SAS-2 07-386r1 Answer

T10/07-415r0

070908_2_contour_scrambled=0_dfe=2_fir=-0.10_cursor=30_baud=6.0e+09.png

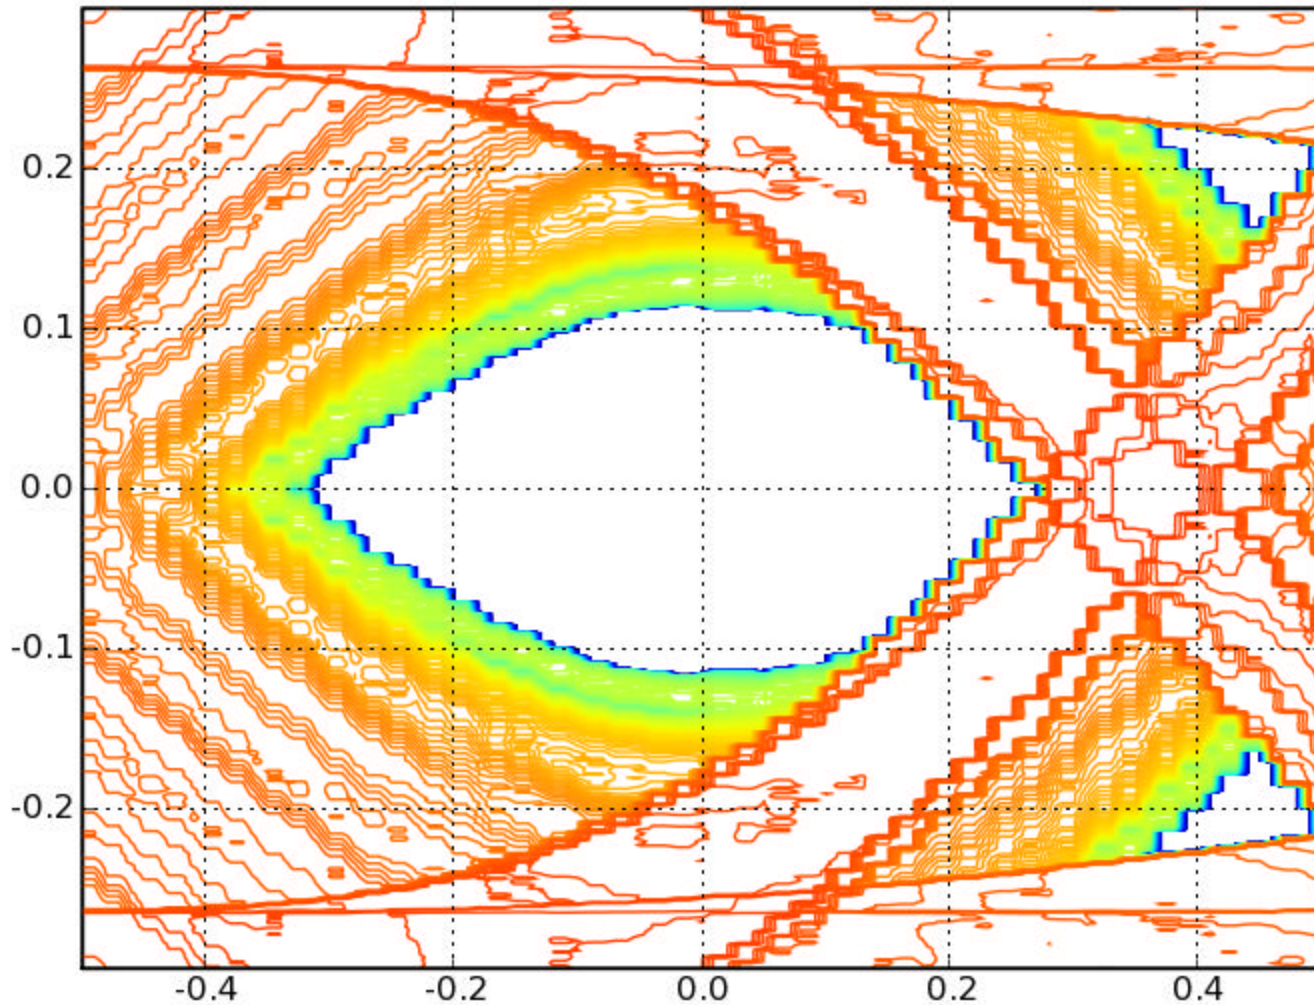
When DFE = 3 there is a slight improvement from 2dB to 3dB. (see included).

This is explainable because of the relative short run length of 8b10b.

When we have 3 taps then this is already correcting the 8b10b ISI that would otherwise be corrected using the de-emphasis.
